Access Compliance Report

Public Rights-of-Way

(Curb Ramps)

Intersection ID: 5784	Main Street: FOSTER_BROOK_DR	Cross Street: OAKDALE_GREEN_DR	Location: W
ADA ID: D5D8F10C72C0	Ramp Type: PerpDiag	Initial Pass/Fail: Fail	Overall Compliance: No
Severity Score: 10			
Codes/Mitigation Info/Possible Solution		Field Measurements/Component Compliance

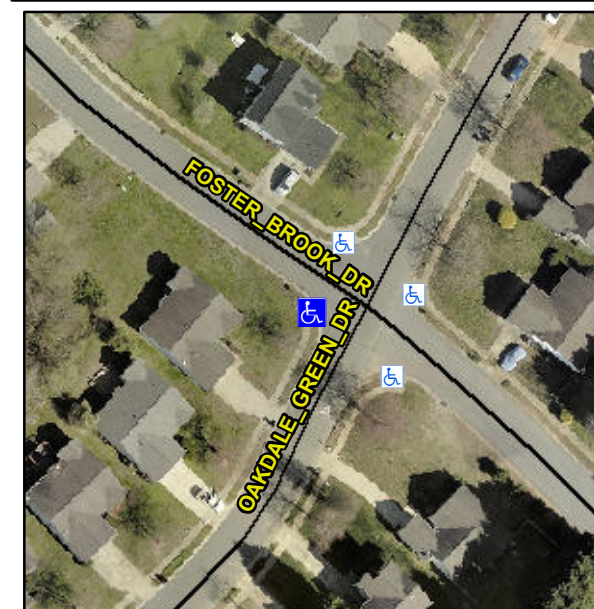
Not Found, R304.5.1, R304.5.3

Compliance	Description	Data	Compliance	Description	Data
N/A	Ramp Length (in)	96.0	Yes	Ramp Slope (%)	6.8
No	Ramp Width (in)	38.0	No	Ramp XSlope (%)	2.8
N/A	Flare Type LT	N/A	N/A	Flare Type RT	N/A
N/A	Flare Slope LT (%)	N/A	N/A	Flare Slope RT (%)	N/A
N/A	Flare Traversable LT?	N/A	N/A	Flare Traversable RT?	N/A
N/A	Landing Length (in)	N/A	N/A	DWS Provided?	N/A
N/A	Landing Width (in)	N/A	N/A	DWS Contrast?	N/A
N/A	Landing Slope (%)	N/A	N/A	DWS Length (in)	N/A
N/A	Landing X Slope (%)	N/A	N/A	DWS Full Width?	N/A
N/A	Landing Curb? (Y/N)	N/A	N/A	DWS Offset (in)	N/A
N/A	Shared Landing?	N/A			
N/A	Gutter Ponding?	N/A	N/A	Gutter Slope (%)	N/A
N/A	Gutter Lip Ht (in)	N/A	N/A	Gutter X Slope (%)	N/A
N/A	Painted X Walk1?	No	N/A	Painted X Walk2?	No
	X Walk 1 Direction	To SE		X Walk 2 Direction	To NE
N/A	X Walk 1 Width (in)	N/A	N/A	X Walk 2 Width (in)	N/A
	X Walk 1 Slope (%)	3.8		X Walk 2 Slope (%)	2.3
	X Walk 1 X Slope (%)	1.1		X Walk 2 X Slope (%)	4.1

Remove & Replace Curb Ramp With Two New Directional Ramps or Equivalent.
